Access Compliance Report

Public Rights-of-Way

(Curb Ramps)

| Intersection ID: N/A | Main Street: SPEER_BV | Cross Street: MILLENNIUM_AV | Location: NW |

| ADA ID: 5A290B67A78A | Ramp Type: Directional1 | Initial Pass/Fail: Fail | Overall Compliance: No |

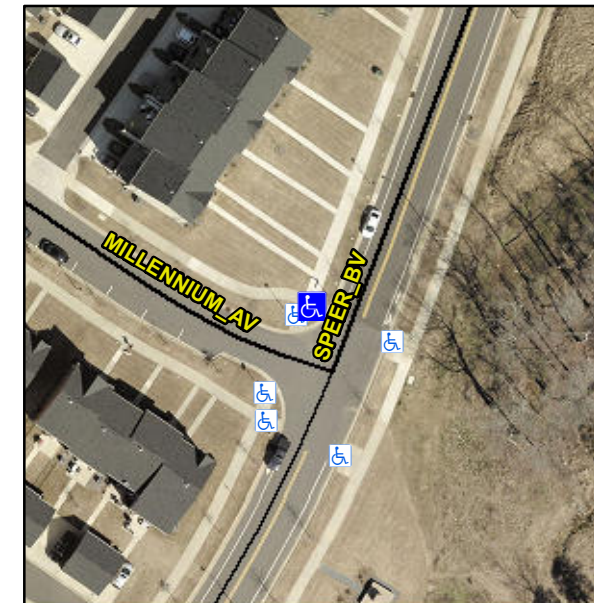
R304.2.2

| Compliance | Description | Data | Compliance | Description | Data |
|------------|-----------------------|------|------------|-----------------------------|------|
| No | Ramp Slope (%) | 8.6 | N/A | Grade Break XSlope (%) | 0.0 |

Possible Solutions:

Remove & Replace Entire Ramp.
